**REQUEST FOR INFORMATION (RFI)**

<b>PROJECT :</b>	BKK2	<b>R.F.I. NO. :</b>	523213-01-RFI-ME-0008								
<b>TO :</b>	CTA	<b>ATTENTION :</b>	CTA								
<b>SUBMITTED DATE</b>	12-Jan-26	<b>NEED REPLY BY DATE :</b>	19-Jan-26								
<b>SUBMISSION OF :</b> <input checked="" type="checkbox"/> Q&A <input checked="" type="checkbox"/> Drawing <input type="checkbox"/> Document <input type="checkbox"/> Others (as specified below)											
<b>SUBJECT :</b> Request for Confirmation - Add Isolation Valve and Check Valve for DRG-ME-0103, 0104 and 0105											
<b>Total Page (s) :</b> 4 (Including this page)											
<b>FUNCTION :</b> <table border="0"> <tr> <td><input type="checkbox"/> Structural (ST)</td> <td><input type="checkbox"/> Electrical &amp; Communication (EL)</td> <td><input checked="" type="checkbox"/> Mechanical (ME)</td> <td><input type="checkbox"/> Vertical Transport (VT)</td> </tr> <tr> <td><input type="checkbox"/> Architectural (AR)</td> <td><input type="checkbox"/> Fire Protection (FI)</td> <td><input type="checkbox"/> Hydraulic &amp; Sanitary (HY)</td> <td><input type="checkbox"/> Other (O)</td> </tr> </table>				<input type="checkbox"/> Structural (ST)	<input type="ch

523213 - 02 - DRG - ME-0105

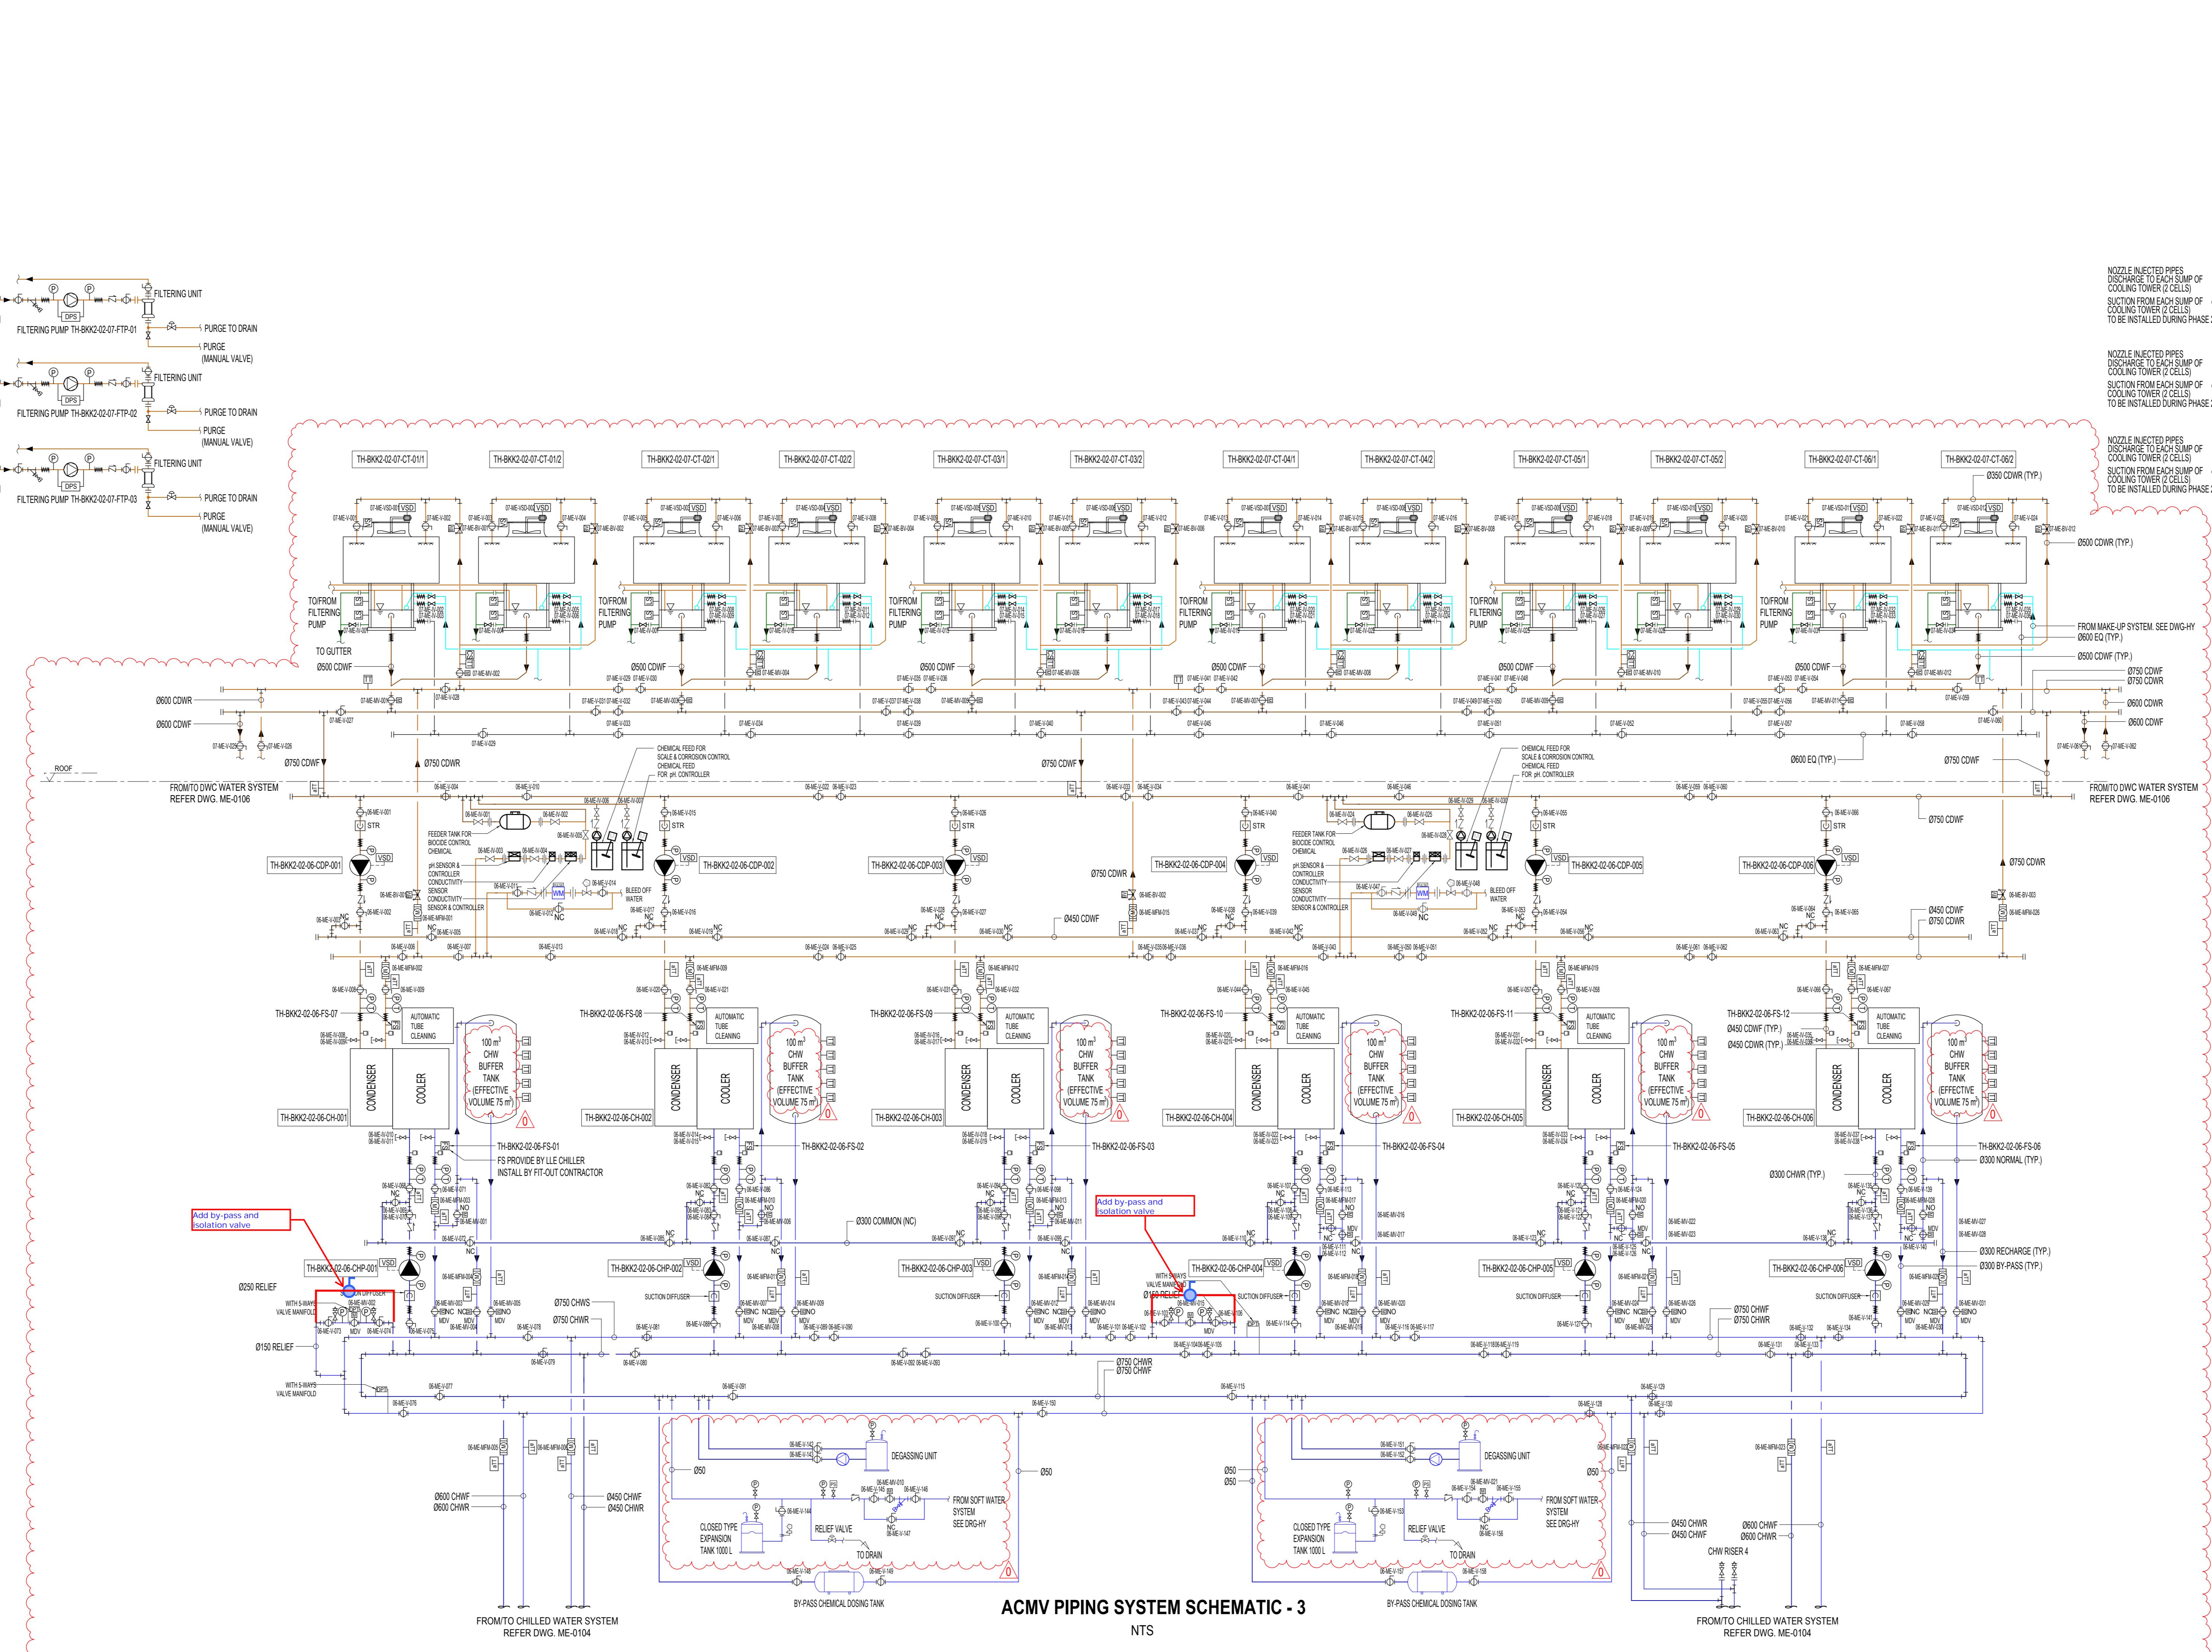
1)With reference to DWG No. 523213-02-DRG-ME-0105, a by-pass line and an isolation valve are proposed to be added for commissioning purposes.

**AUR: Please canceled all the purposed check valves and isolation valves by contractor because the system can still maintain concurrently maintainable without the purposed valves**

Note : 1. Please canceled all the purposed check valves and isolation valves by contractor because the system can still maintain concurrently maintainable without the purposed valves  
2. Please add the valves purposed by Aurecon in Green Highlighted only

**ACMV PIPING SYSTEM SCHEMATIC - 2**

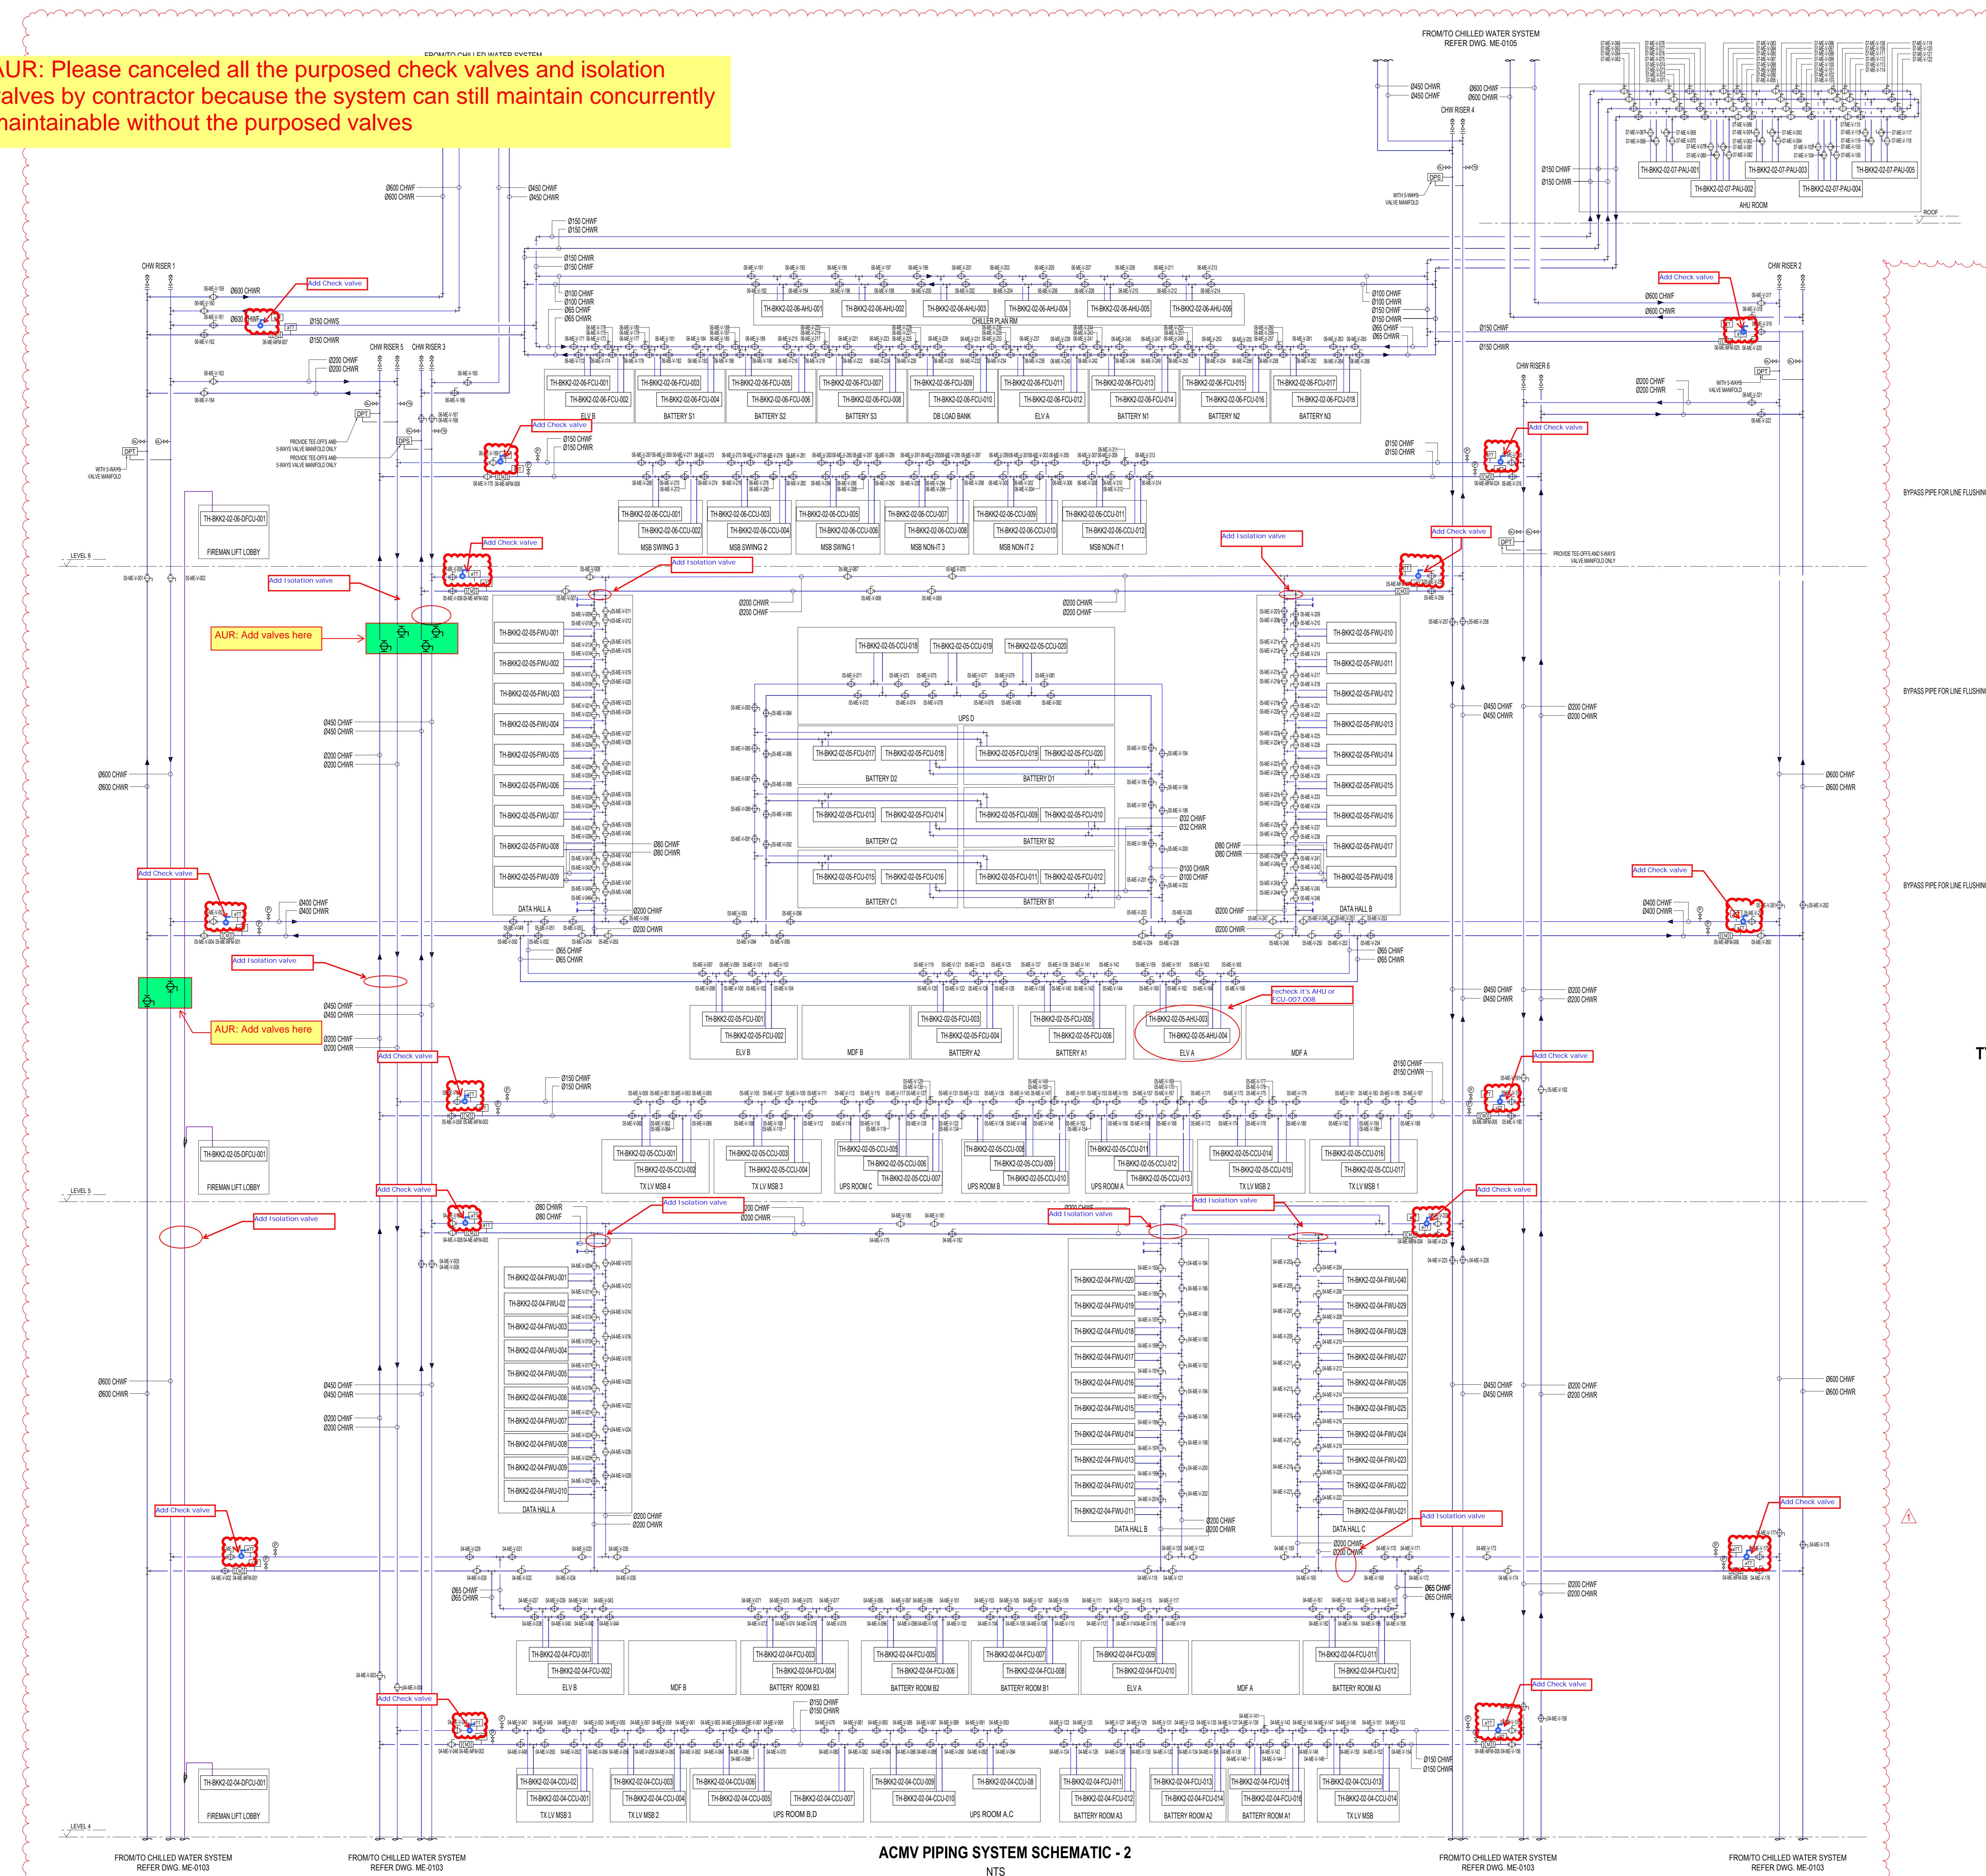
2)With reference to DWG No. 523213-02-DRG-ME-0103,0104, a check valve on the CHWF pipes is proposed to be added at each branch from the riser for commissioning purposes.

AUR: Please canceled all the purposed check valves and isolation valves by contractor because the system can still maintain concurrently maintainable without the purposed valves
